**Recommendations of the Risk Informed Steering Committee
Working Group on PRA Technical Adequacy**

December 2014

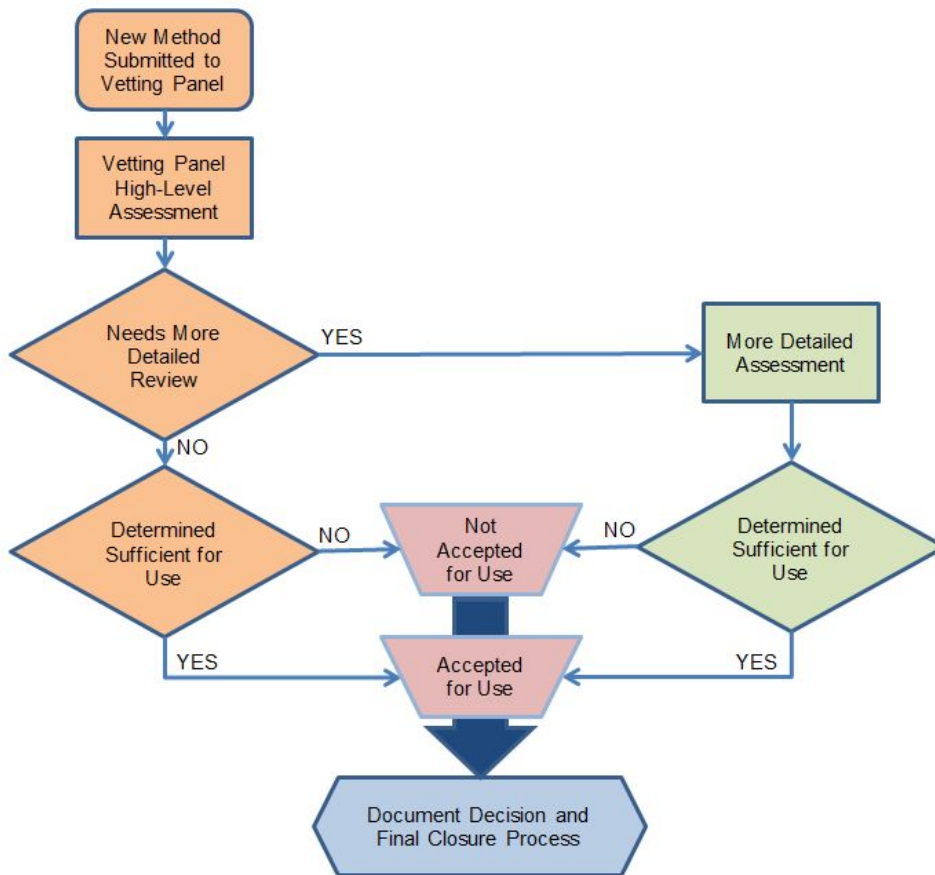
Comment [NRC13]: The NRC agrees that more detailed guidance (similar to Appendix 1) is needed as part of the pilot process to determine its practicality and revise the guidance as appropriate.

However, for this part of the discussion in the whitepaper, the NRC staff considers a high-level conceptual flowchart to be more useful for explanatory purposes.

See recommended insert.

Comment [NRC17]: As written, this appears to be inconsistent with the Appendix 1 figure. This description seems to imply that a method that does not pass a peer review or meet RG 1.200 in a gap assessment can still be used by a licensee in an application so long as the licensee addresses the failings of the method, as identified in the peer review or gap assessment. The Appendix 1 figure implies that such a method would not be accepted for use.
